Item Name: Crosstube Turning Detail

<b>DART AEROSPACE LTD</b>	<b>Work Order:</b>	<b>88222</b>
<b>Description:</b> Crosstube Assembly (412 High Aft)	<b>Part Number:</b>	<b>D412-664-243</b>
<b>Inspection Dwg:</b> D412-664-243 <b>Rev:</b> E		<b>Page 1 of 2</b>

DRAWING NO. D412-664-243	TITLE CROSSTUBE ASSEMBLY (412 HI AFT)	REV. E	DART AEROSPACE LTD ENGINEERING ORDER		D.E.O. NO. D412-664-243-E-1	SHEET NO. SHEET 1 OF 2	SCALE NTS
DRAWN	CHECKED <i>MP</i>	MFG. APPR. <i>E</i>	APPROVED <i>MP</i>		DE APPR. <i>MP</i>		
DATE 11.03.31	DATE 11/03/31	DATE 11.03.31	DATE 11/03/31		DATE 11.03.31

REMOVED ABRASION STRIP IN FAVOR OF A THIN LAYER OF PROSEAL 890.

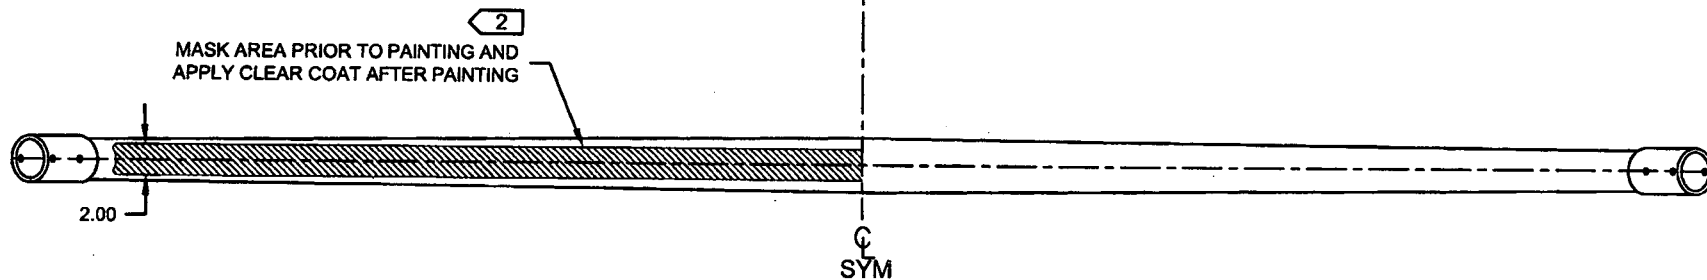
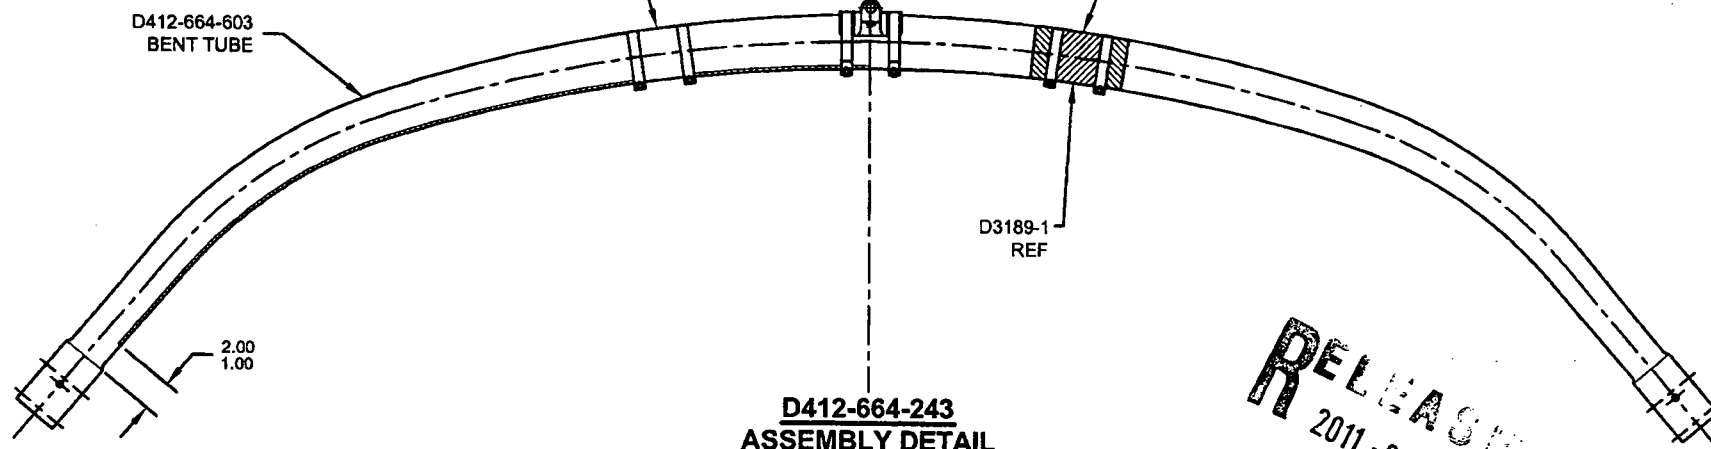
D3189-1 CHAFING SHIELD (1, INSTALLED OVER PROSEAL 890)  
MS21920-28 CLAMP, 2X  
2 PL

D2856-600-1009 ABRASION STRIP  
D3189-1 CHAFING SHIELD (1, INSTALLED OVER ABRASION STRIP)  
MS21920-28 CLAMP, 2X  
2 PL
